ACCESSIBILITY ASSESSMENT

ADA TITLE III ASSESSMENT

Centennial Elementary School

March 4, 2025

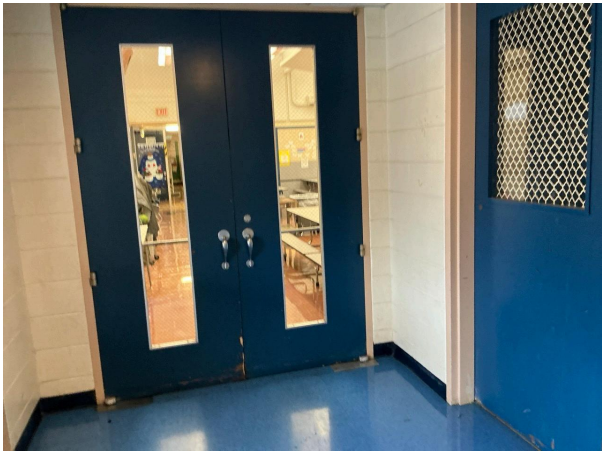
Assembly	Interior Access Route
Type	Door
ADA Standard	404.2.9
Barrier Detail	The fire door requires more than the allowable pounds of pressure to operate.
Location Description	Cafeteria Dining (Interior) Entrance Door
Observed	Jan 14, 2025 by Thomas.chiarella@bureauveritas.com
Site Conditions	Force to open is 16 pounds at each door.

Provide a fire door which operates at the minimum force allowable by the governing administrative authority. The force required to open and close the fire door shall be not greater than the minimum force allowable by the appropriate administrative authority. Fire doors shall have a minimum opening force allowable by the appropriate administrative authority. The force for pushing or pulling open a door or gate other than fire doors shall be as follows: 1. Interior hinged doors and gates: 5 pounds (22.2 N) maximum. 2. Sliding or folding doors: 5 pounds (22.2 N) maximum. These forces do not apply to the force required to retract latch bolts or disengage other devices that hold the door or gate in a closed position.
